00	13-AUG-22	FOR APPROVAL	H.K.	M.O.	A.M.	A.M.
REV.	DATE	POI	PREP. BY	CHKD. BY	APPD. BY	AUTH. BY
EIED			SCALE: N.T.S.			
DRAWING TITLE: CONTROL SYSTEM BLOCK DIAGRAM						
DRAWING NO.			Class	REV.	SHEET No.	SIZE
			1	00	1 OF 1	A3

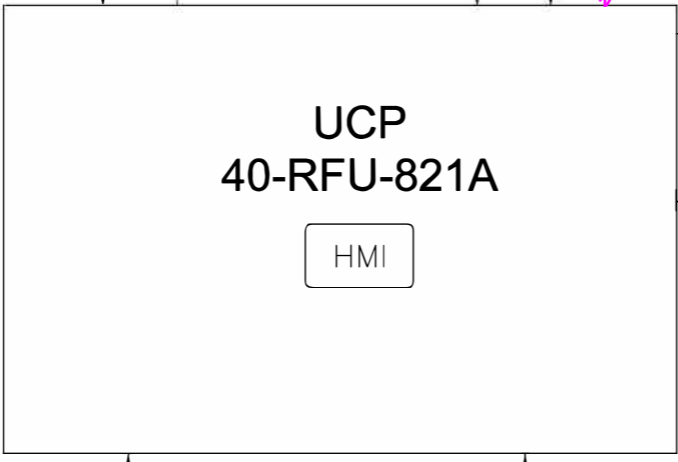
The PLC shall be based on proven and reliable technology satisfying TUV requirements and approvals for SIL-3 according to IEC-61511 or AK6 according to DIN V 19250.

Isolators for safety loops shall have sufficient SIL certification based on result of HAZOP and SIL study.

For shutdown related signals, the IO card shall be fail safe, SIL3 and redundant.
conclusion meeting(2024/02/17):
comment is applicable for ESD signals

Vendor's PLC shall have capability to receive time synchronization signal (a bit) from plant DCS. Hardwire signal should be considered by Vendor for real time synchronization.

CPU shall be redundant but there is no conclusion in this regard ,please clarify.

Power supply, CPU and communication modules of PLC to be redundant.
For close control loop (If any), the redundant IO card, shall be considered.
conclusion meeting (2024/02/17):
power supply, communication modules of PLC to be redundant.
For close control loop (If any), the redundant IO card, shall be considered.

One operator station (including PC, monitor, keyboard, mouse and relevant interconnection cables to PLC panel) shall be considered for installation in control room.
conclusion meeting(2024/02/17):
engineering laptop including related software instead of operator station shall be considered
field instrument transmitters shall be considered as EXi

1. all required software for configuration of PLC , HMI monitoring , configuration/monitoring functionality through Hart protocol (Configuration/Calibration of Smart instruments trough engineering laptop) shall be supplied by vendor on engineering laptop.

Redundant DI & DO signals shall be foreseen by vendor for communication with plant hardwire console (Supplied by others).
HS-50301 (Emergency Stop Signal; Trip PU-5001)(NIS,REDUNDANT,PASSIVE,24 VDC / POTENTIAL FREE CONTACT)
HL-50301 (Common shutdown alarm from package PLC (UCP) to Plant HWC)(NIS,REDUNDANT,PASSIVE,24 VDC (CONSUMER LOAD))

Please note that LCP (local control panel) is in vendor scope of work/supply and all motors and heaters (main motors and auxiliaries) shall be controlled via this Local Control Panel. All control signals- commands and indications will be sent from this vendor local control panel to the UCP and then will be transferred to MCC from UCP based on agreement between electrical and instrument department. Please confirm.
conclusion meeting (2024/02/17):
noted

conclusion meeting (2024/02/17):
S7-300 F is accepted by client for PLC

NOTE
vendor reply: As a system Vendor meets SIL-3 but the transmitters are only rated for SIL2. Also, the application is a refrigeration package and SIL2 is more than suitable and safe. The offered system will include a fail safe sequence to stop the compressor in both option NORMAL STOP, and sudden SHUTDOWN.

Vendor reply: This is not agreed with client

Vendor reply: Confirmed

Vendor reply: refer to TCL

Vendor reply: Confirmed that all hardwired signal for ESD will be wired to two different DI card to assure redundancy.
Vendor offer requires all signal in dry state.
In addition, the system detect BAD PV for any device that failed.
